# MM Knit Wear (Extension Buildings)

8 June, 25 August & 6 September 2021

# Observations

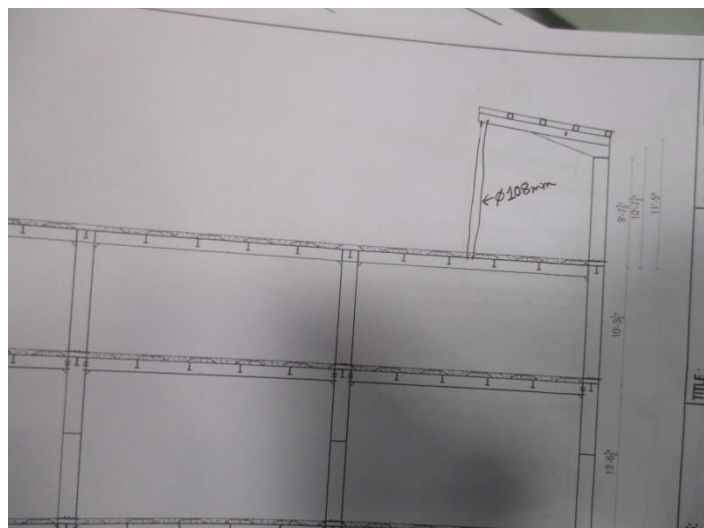
Steel pipe column in grid- 4

Steel pipe column in grid- 2, 3

Size of steel pipe column in grid- 2, 3 & 4 has not mentioned in the drawings. The factory is required to survey the structure and update the as-built drawings accordingly.

Bracing layout

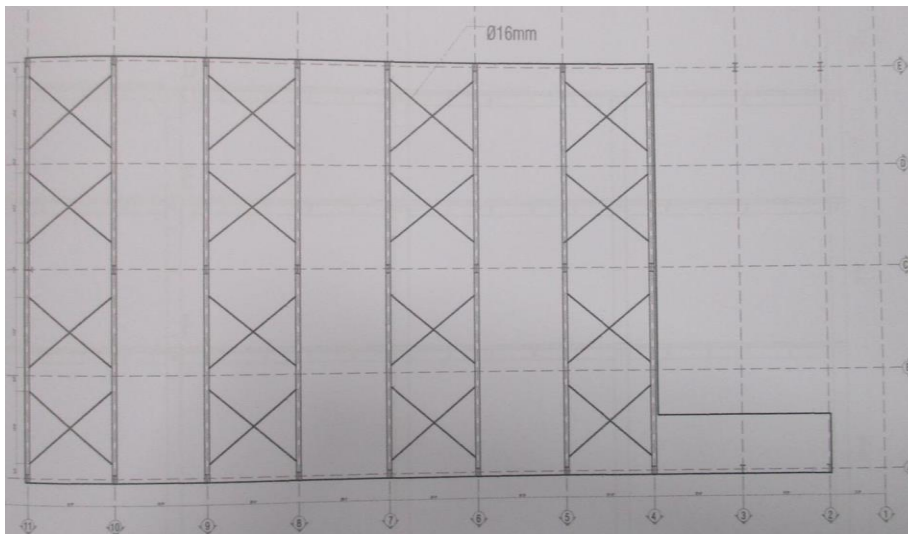
No compression member at ridge

No compression member at eave

No compression member at the roof and lateral load transfer media is absence. The factory is required to determine the size, position of load transfer media and install accordingly.

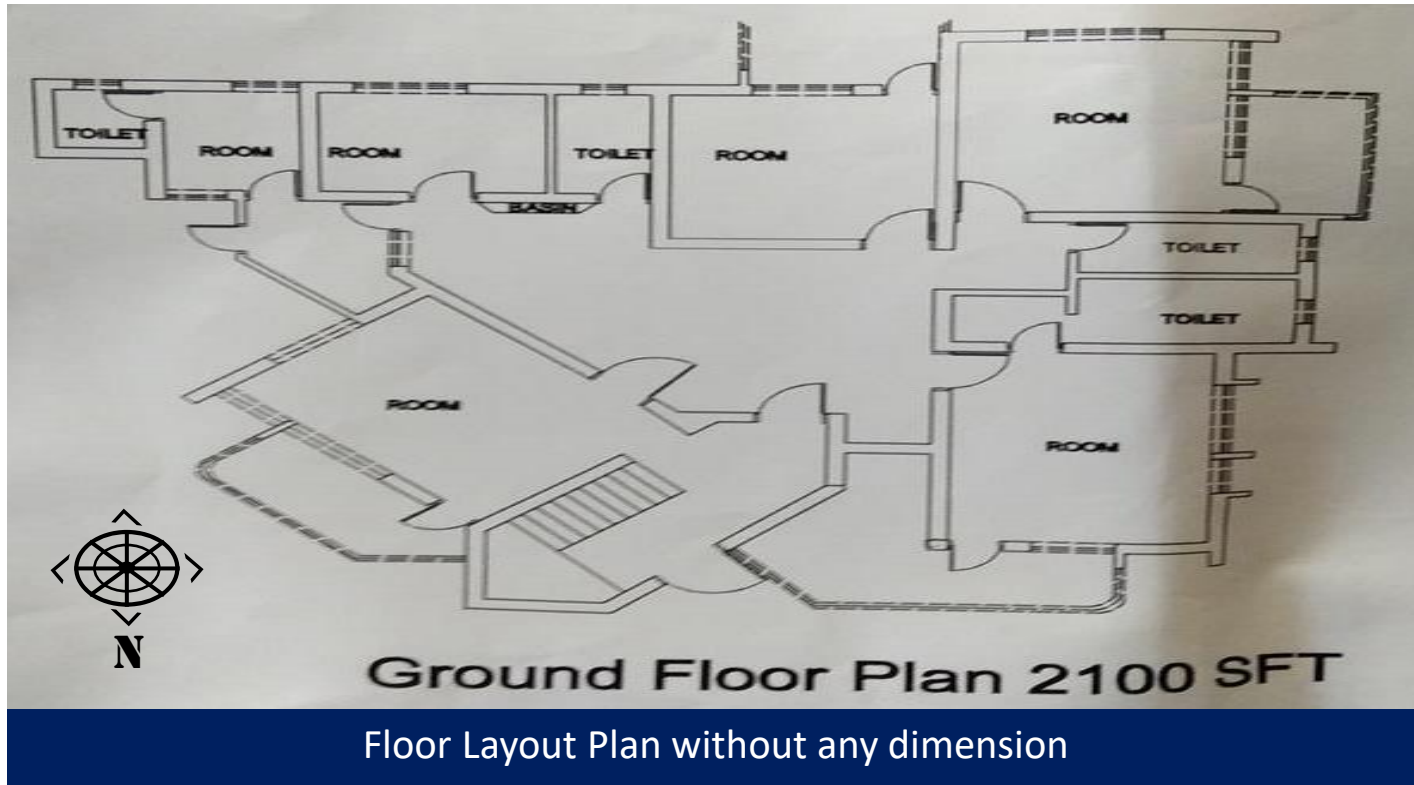
PVC water tank rest on parapet wall

No parapet wall in some area of the roof

Provide adequate support to the water tank to prevent accidental event cause by lateral load. Check the load bearing capacity of the wall beneath the water tank. Construct parapet wall at all edges of the roof.

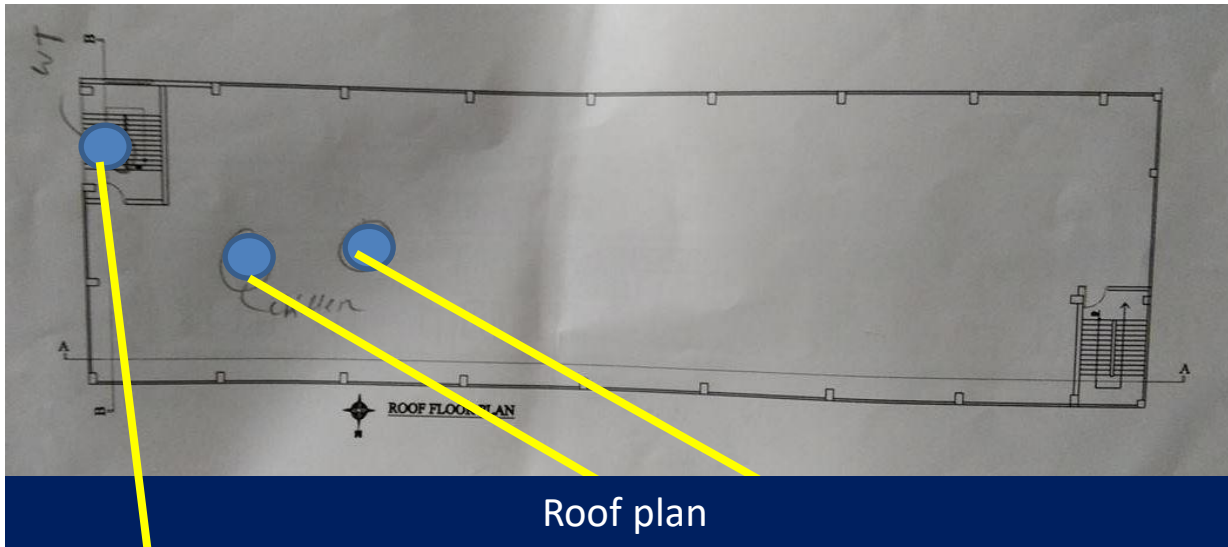
**Water ponding on roof**

Factory is required to develop proper drainage system on roof with adequate slope or apply water proofing compound on roof slab to resist water ingress.

Water ponding on roof

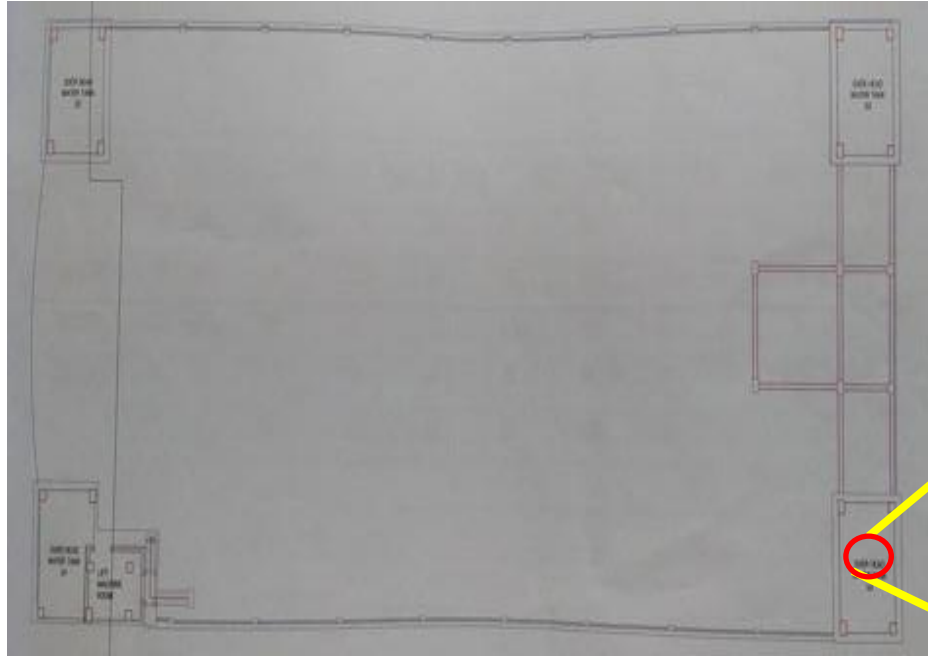
Vegetation

Factory is required to develop proper drainage system on roof with adequate slope and apply water proofing compound on roof slab to resist water ingress.

Roof Layout Plan

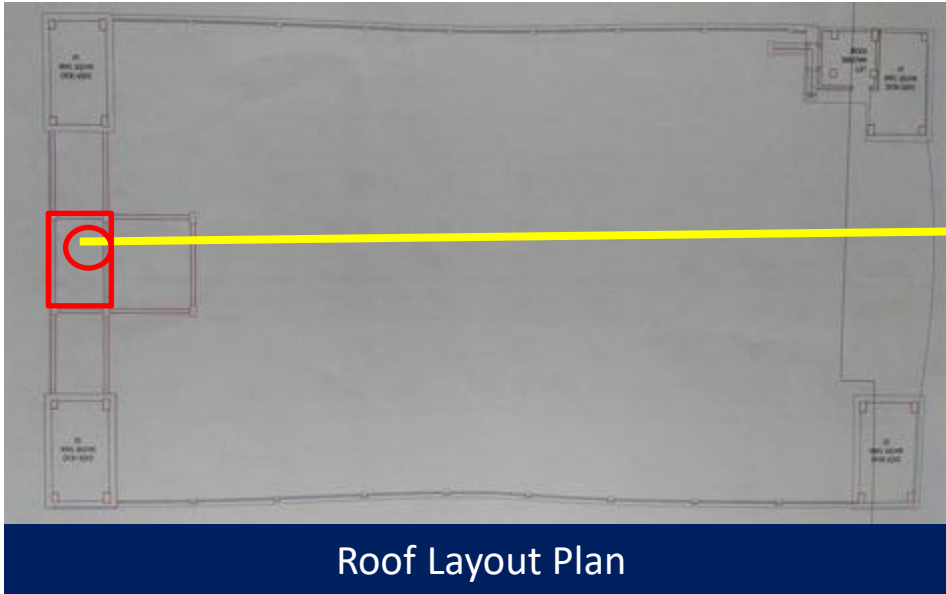
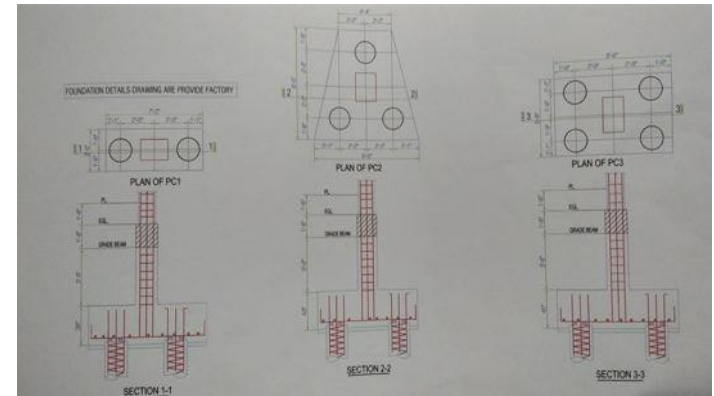
Chiller machine and stair not mentioned in the drawing

Undocumented steel stair

Chiller Machine and roof top shed not mentioned in the drawing

Factory engineer is required to survey all the structural elements and produce correct as-built drawings accordingly.

Truss Section

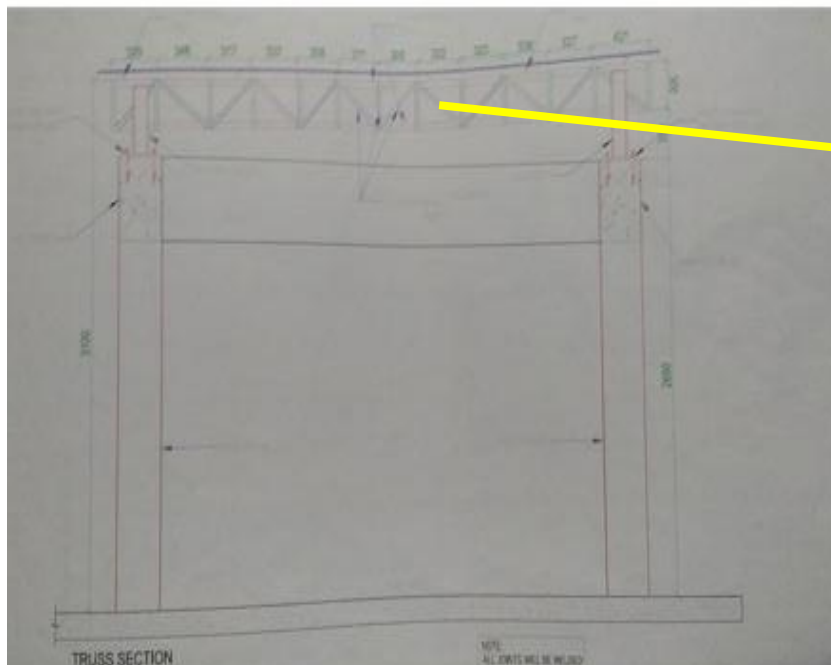
Rebar details are not mentioned in the pile cap drawing

Connection details for truss sections not shown in the drawing

Missing Bolts

Factory engineer is required to install the missing bolts and carry out connection adequacy check for all the connections and implement remedial work accordingly. Moreover, no roof bracing or compression member was observed in the shed during inspection. Factory engineer is required to carry out lateral stability check for this steel shed.

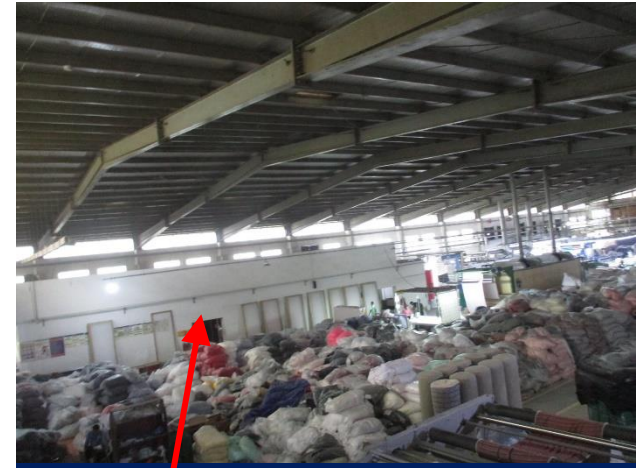
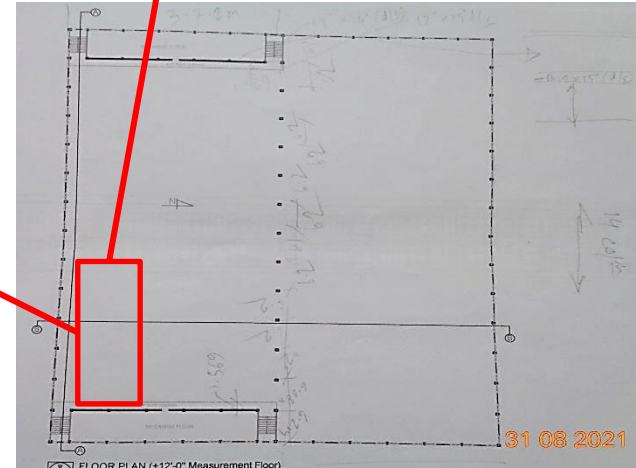
Bracing layout missing

Floor void not shown in drawing

14 column grid onsite

Steel frame not shown in drawing

This room not shown in drawing

15 column grid in drawing

Number of column grid did not match with provided drawings. Roof bracing layout, void in floor, stair steel framing and ground floor accessories rooms were missing in the provided drawings. The factory engineer is required to survey the structure and prepare a set of as-built drawings accordingly.

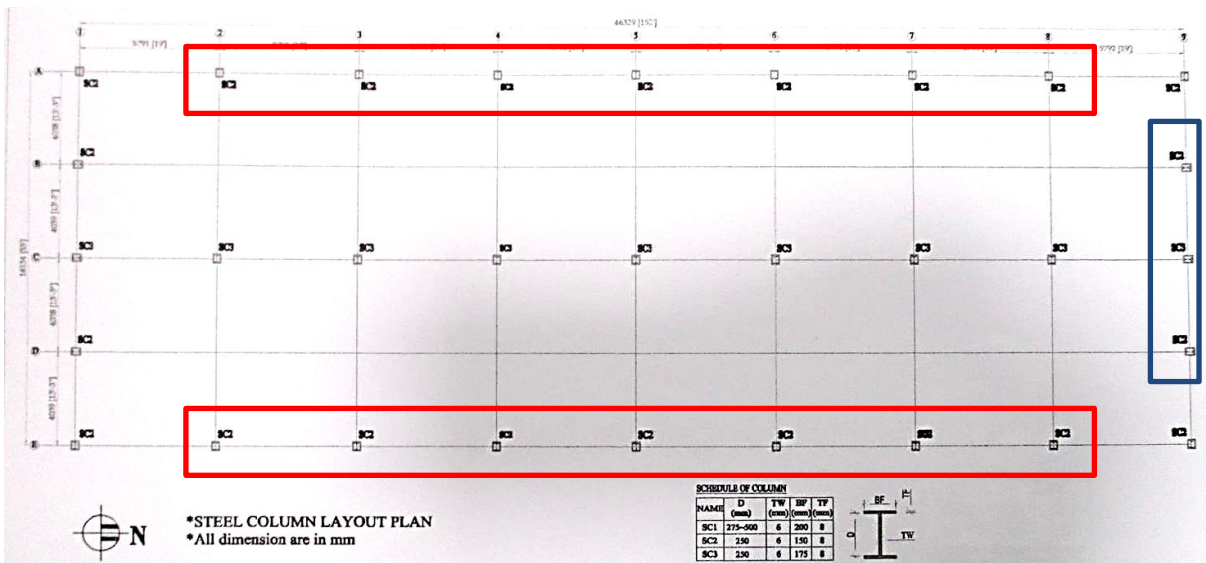
No bracing system at roof

Poor connections

No bracing and lateral load transfer media is provided in the roof of this structure. Also, poor connection details of truss observed. The factory engineer is required to check lateral stability of the structure and suggest necessary measure accordingly.

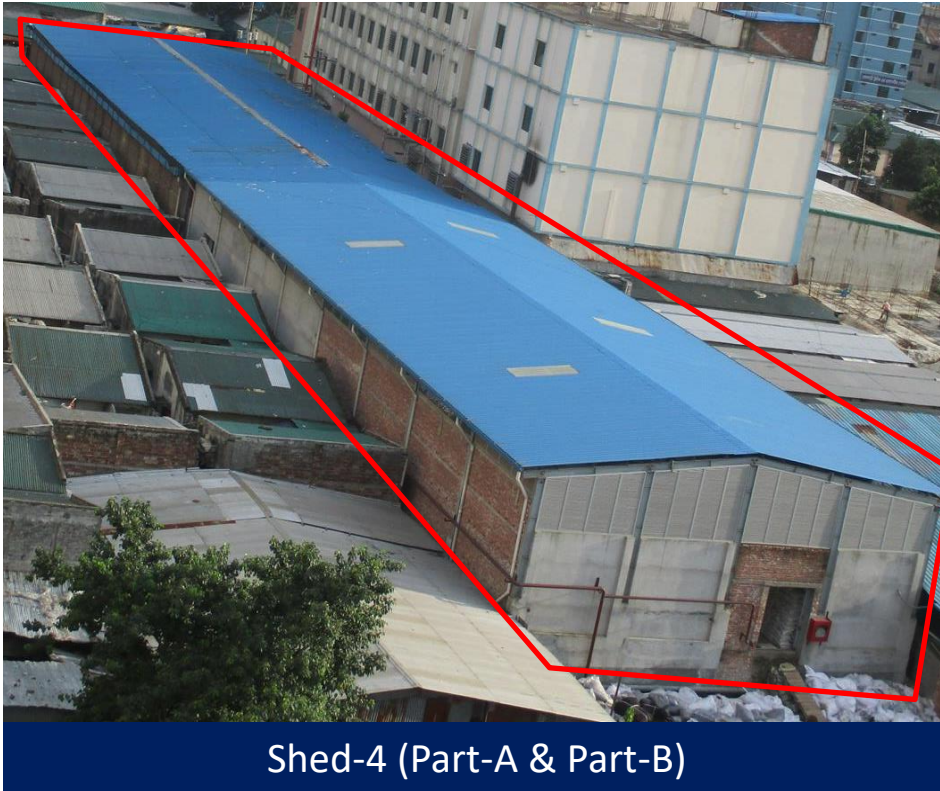
Poor connection

No bracing system; Rafter deflection at roof level in Part-A

The rafter is deflected and there is no bracing system in part-A of Shed-4. The factory engineer is required to check the adequacy of the rafter and connections for gravity and lateral forces. Also, check the lateral stability of the structure and suggest necessary remedial actions accordingly.
